April 1, 2025

Current Zoning: UC (Uptown Core)
Proposed Zoning: UC(EX) (Uptown Core, Exception)

The petition proposes the redevelopment and expansion of existing stadium facilities on property developed with the Bank of America Stadium.

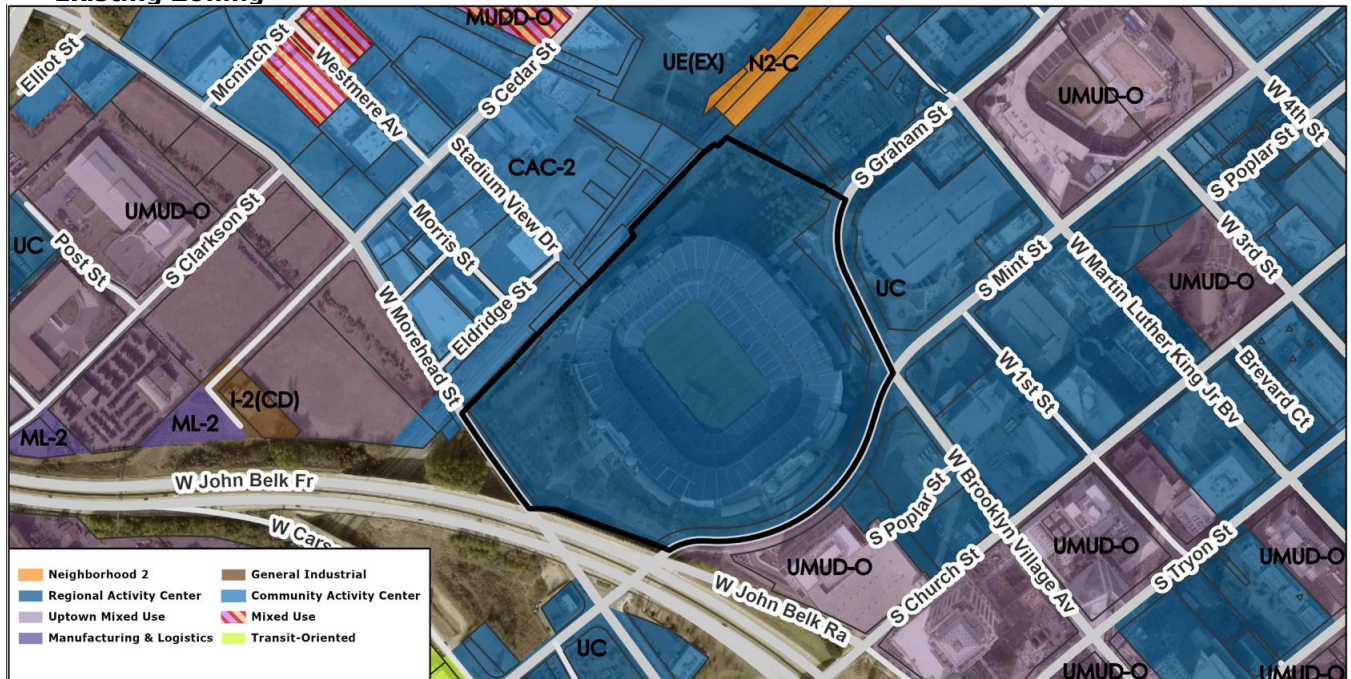
- ~~1. Conditional note 6.d. regarding improvements to South Graham Street and South Mint Street needs to be updated to state that the development will construct the required streetscape. CDOT requires clear language about it being constructed as part of this development when triggered according to ordinance requirements. **Addressed**~~

- ~~2. Revise language for the second city improvement public benefit to wholly commit to construction of option (ii) completion of the shared use path between Graham Street and the proposed practice facility path. **Addressed**~~

- ~~3. Provide more specific and committal language about when the city improvement benefits will be completed by. **Addressed**~~
- ~~4. Revise site plan and conditional note(s) to commit to updating conditional note 6.c. and change triggers for streetscape to align with UDO requirements or request an EX provision to modify this standard. Streetscape upgrades are required per ordinance when triggered. Adjustments to small portions of streetscape due to topography, trees, etc. may be made during the permitting phase according to allowable exceptions. **Addressed**~~

- ~~5. Add a conditional note specifying "the Petitioner shall dedicate and convey in fee simple all rights of way to the City before the site's first building certificate of occupancy is issued. CDOT requests rights of way set at 2' behind back of sidewalk where feasible." Conditional note 6.b. does not read clearly enough to verify the understanding that all right of way that is required by ordinance will be dedicated. Update to read exactly as shown above or update existing note(s) so that it is very clear what improvements would not have right of way dedicated. **Addressed**~~

- ~~6. Revise public amenity language to add more detail regarding closures of the space, such as no more than 24 hours around certain events. **(Addressed)** Provide quantitative measures for how frequently per-square-foot elements will be placed in the open space including but not limited to seating, lighting, and plantings. **(Outstanding)** Increase the minimum depth of the space from 25' to 50'. **(Addressed)** Commit to providing a public art feature within an open space area using previously provided public art feature language from UDC but with slight modifications to note that rather than the petitioner "seeking input from UDC" during the land development process regarding possible artists, the petitioner will procure the most recent list of creative pool artists from UDC. Additionally, the public art feature language should reflect that the location, type of art, and size of the art must be determined during land development processes. **(Outstanding)** Clarify reasoning as to why this benefit cannot be completed earlier than May 31, 2030. **(Addressed)**~~

- ~~7. Work with Urban Forestry on protecting existing trees located within the ROW since the existing curb is to remain and revise conditional notes to commit to this. **Addressed**~~

- ~~8. Remove reference to Alternative Compliance Review Board process in note 3.b. as it is unnecessary. **Addressed**~~
- ~~9. Add EX provisions related to exterior lighting, design of surface parking, design of bicycle parking, and design of parking structures to the EX table. **Addressed**~~
